AMENDMENTS TO THE DRAWINGS

ZHANG, J. et al.
Appl. No. 10/800,014
December 4, 2006

FIGURE 3

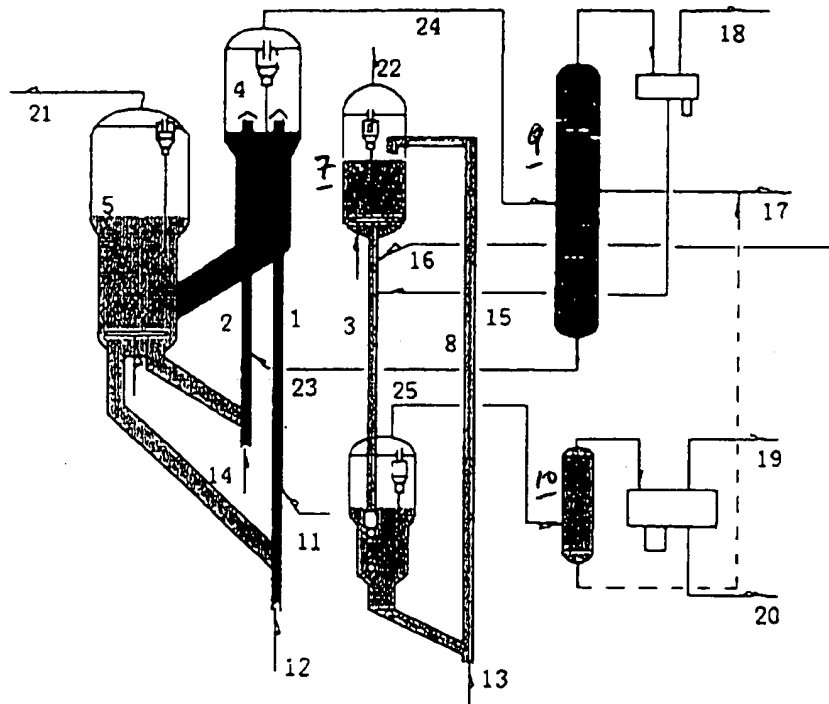
The attached three Replacement sheets of drawings includes changes to Figure 3 indicated in the corresponding attached Annotated Sheet of Figure 3. Specifically, Figure 3 has been revised to include an indication of tanks 7, 9 and 10. No new matter has been added.
